COUNCIL SUBMISSION - Environmental Impact Statement (EIS) for Sydney Metro West Stage 3 – Rail infrastructure, stations, precincts, and operations

EXECUTIVE SUMMARY

Figure 1: Public Domain, Street & Deep Soil provision

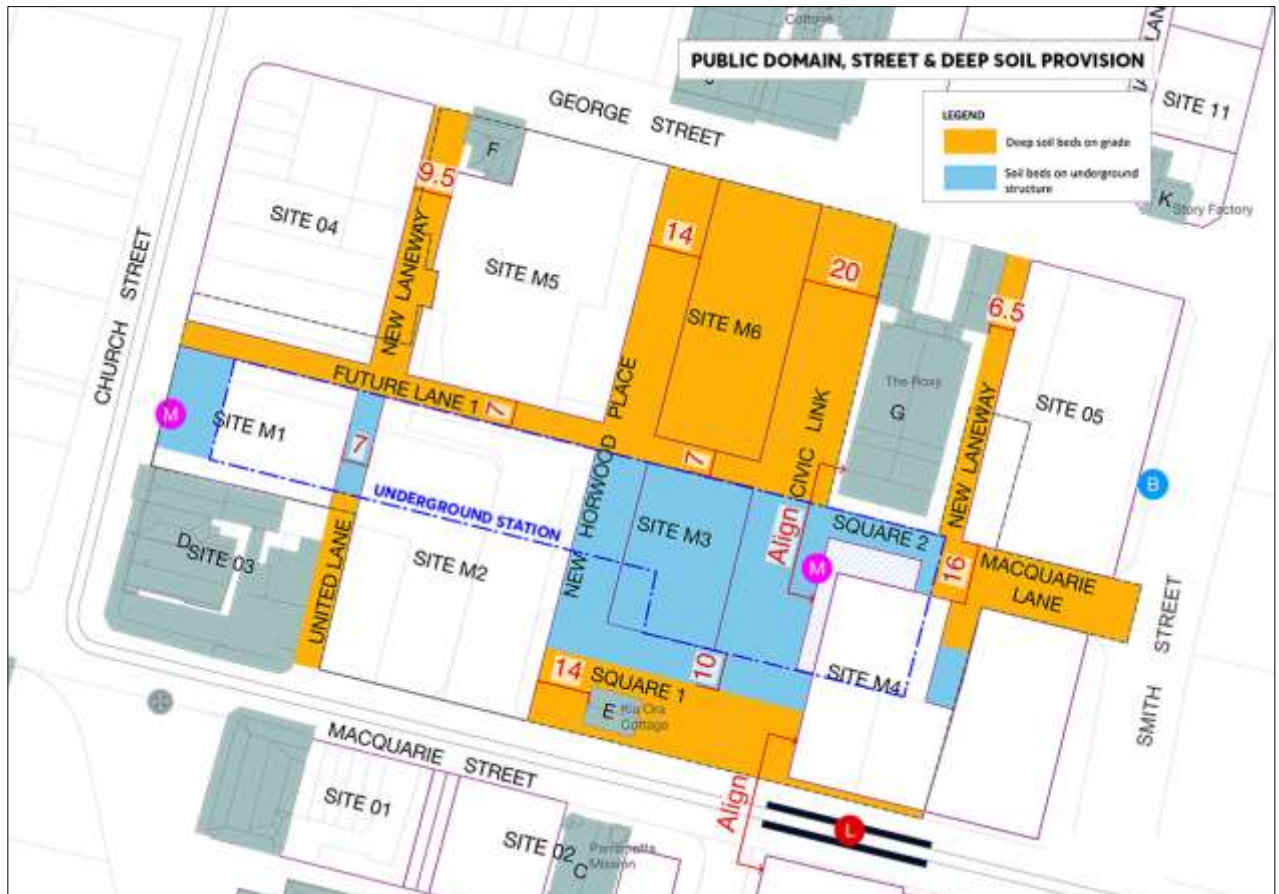
Hence, Council proposes the conditioning of Figure 1 – Public Domain, Street and Deep Soil provision, Table 1 – Deep Soil Beds on Grade (City of Parramatta Public Domain Guidelines), Table 2 - Requirements for Soil Beds on Underground Structure (2015 Apartment Design Guide – DPE) and Figure 3 – Soil Bed Depth on Underground Structure – all contained within **Attachment 1**.

- The SSI Planning Approval incorporate Figure 1 – Public Domain, Street and Deep Soil provision, Table 1 – Deep Soil Volume on Grade (City of Parramatta Public Domain Guidelines), Figure 2 – Deep Soil Depth on Grade, Table 2 - Soil Bed Volume on Underground Structure (2015 Apartment Design Guide – DPE), and Figure 3 – Soil Bed Depth on Underground Structure, as Conditions of Approval.
- That the SSI Planning Approval condition all vehicle access, service access, and parking for the proposed buildings to be wholly contained within the building footprints and not under public domain, as shown in Figure 1. Detailed access and servicing arrangements to adjacent properties to be the subject of a design to be developed by Sydney Metro in consultation with City of Parramatta (post consent and before the construction of the station and structures for non-station use).

Figure 2 – Deep Soil Depth on Grade

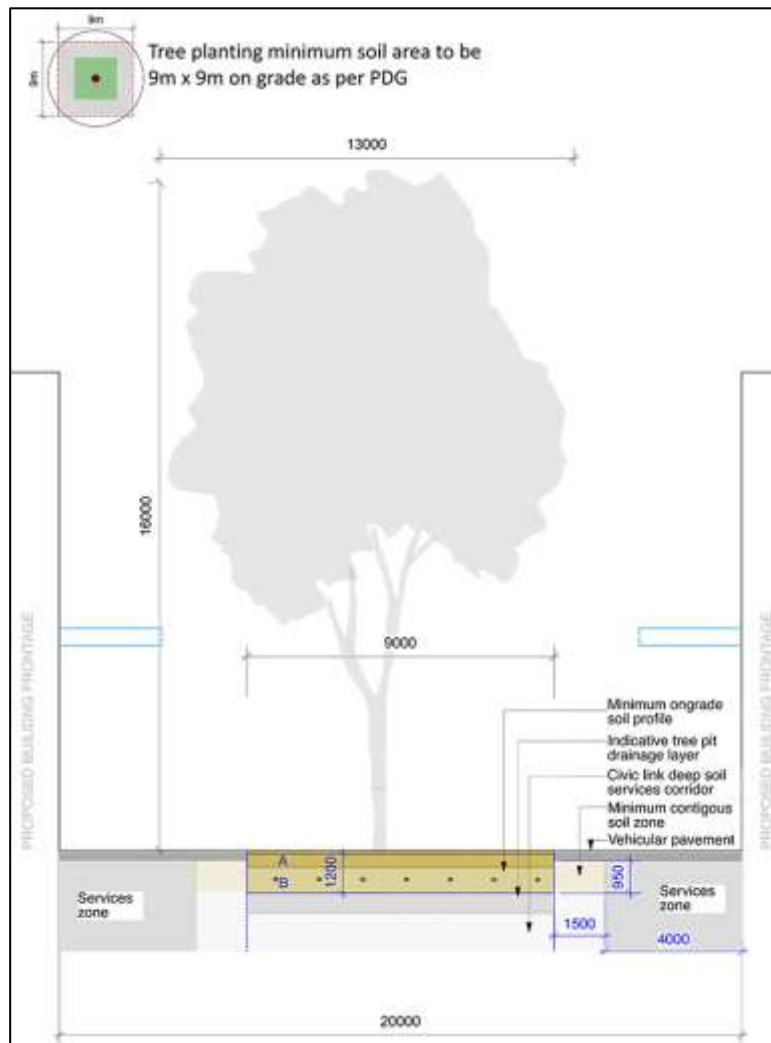
- Provision for minimum 1800mm slab drop down or other mechanism for providing deep soil provision (Tables 1-2, Figures 1-3 in Attachment 1), must be conditioned within the Planning Approval for over station and adjacent station development within the Civic Link.
- Provision for minimum 3000mm slab drop down or other mechanism for provision of services, with service access provided from surface and no suspended services in underground structures for over station and adjacent station development within the Civic Link.

Figure 3: Soil Bed Depth on Underground Structure

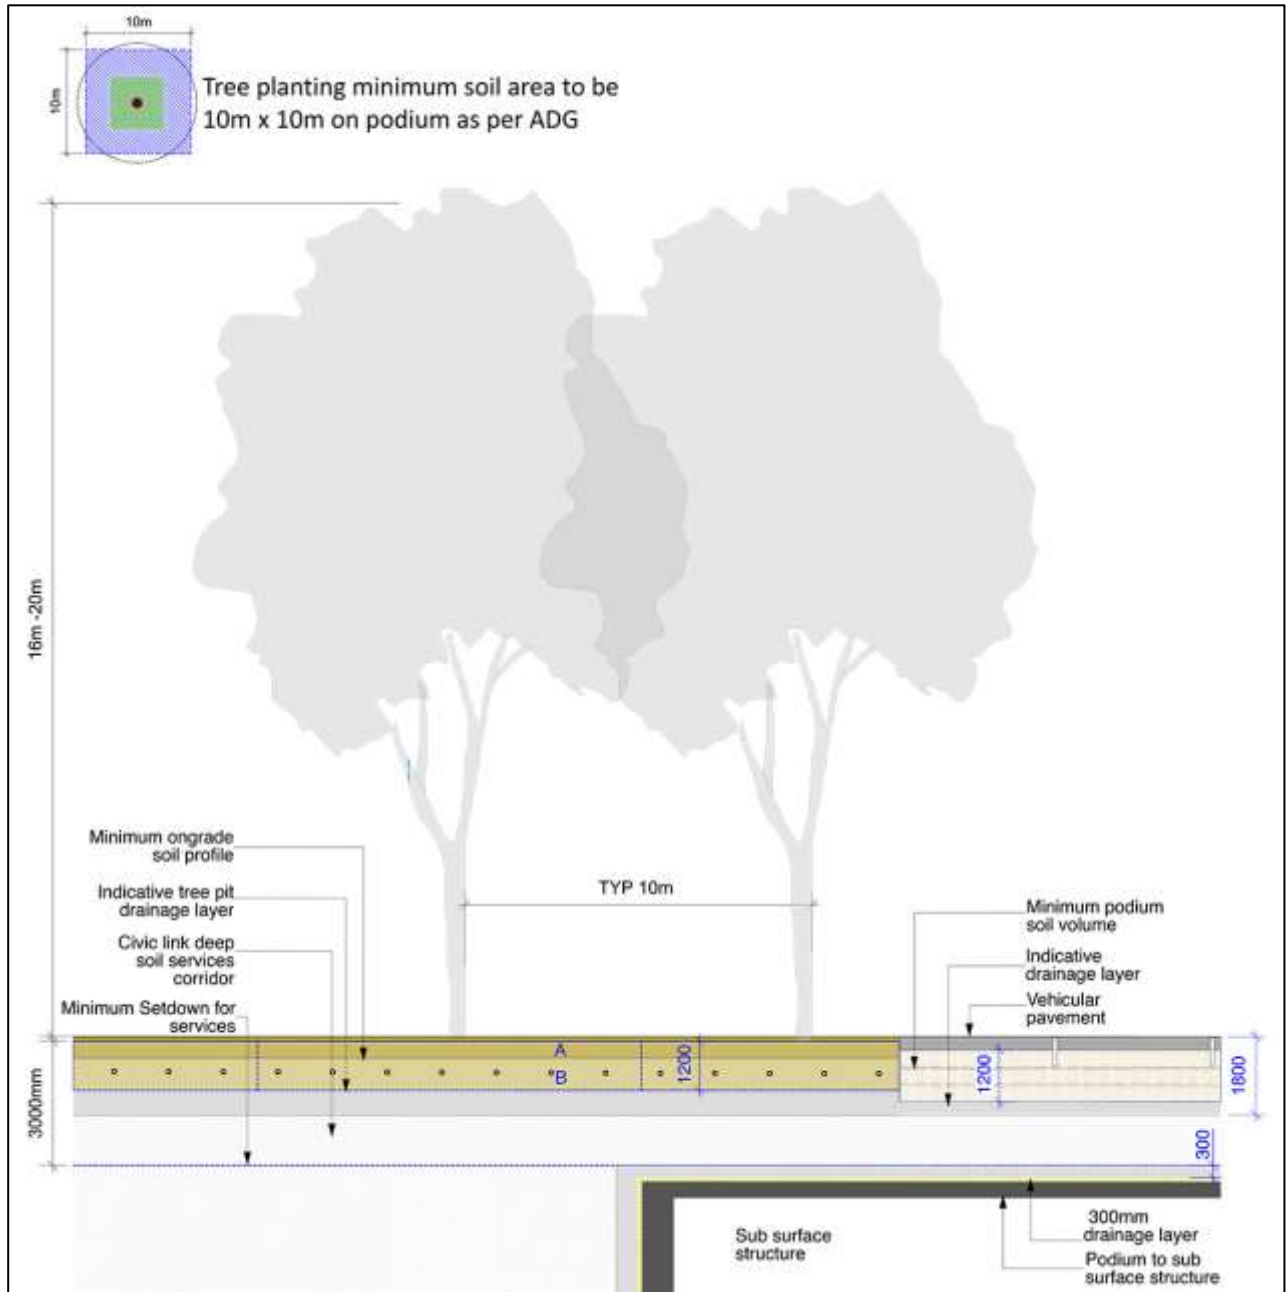
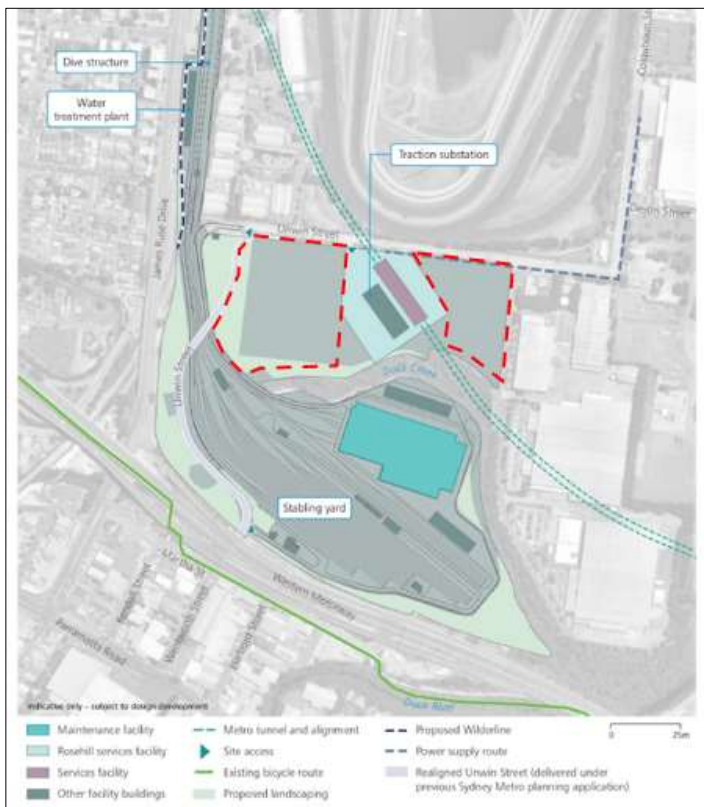
The basement structures to support future over and adjacent station development, along with the Station Box fit out, must be designed to provide the slab drop down to allow deep soil planting, per Figures and Tables in **Attachment 1**. It will be too late to leave this critical element to a 'future' approval, when the basement structures for future commercial development are part of this EIS and Planning Approval. It is recommended that:
